Staff Report to the Western Weber Planning Commission

Application Information Application Request: Agenda Date: Applicant: File Number:	Consideration and action on a request for final approval of the Favero's Legacy Cluster Subdivision Phase 1. Wednesday, April 26, 2017 Robert Favero LVF051916
Property Information	
Approximate Address: Project Area: Zoning: Existing Land Use: Proposed Land Use: Parcel ID: Township, Range, Section:	3750 West 2200 South 8.302 Acres Agricultural (A-1) Residential/ Agricultural Residential 15-078-0137 T6N, R2W, Section 28
Adjacent Land Use	
North: Residential East: Agricultural	South: Agricultural West: Residential
Staff Information	
Report Presenter: Report Reviewer:	Felix Lleverino flleverino@co.weber.ut.us 801-399-8767 RK

Exhibit B

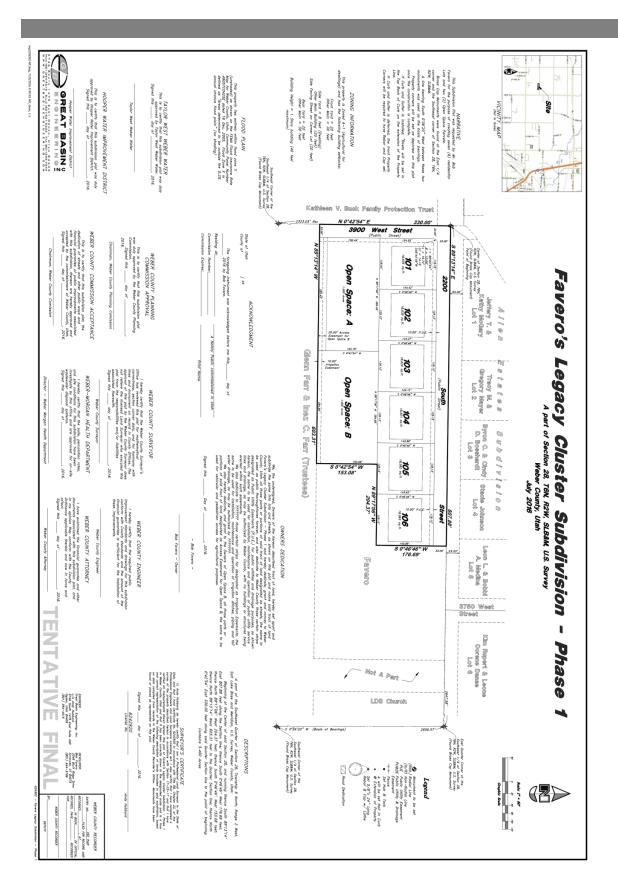
The proposed lots range in area from 18,563 square feet to 18,635 square feet and vary from 119.19 feet to 129.13 feet in lot width which adheres to the above described design criteria for cluster subdivisions. The yard setbacks for the Favero Cluster Subdivision Phase 1 are as follows:

However, it appears that the applicant has opted to implement a buildable envelope that will restrict the area where the home and outbuildings can be located. This building envelope is self-imposed and not required by the LUC. As part of Phase 1 the applicant will also be dedicating a half-width right of way to continue 3900 West.
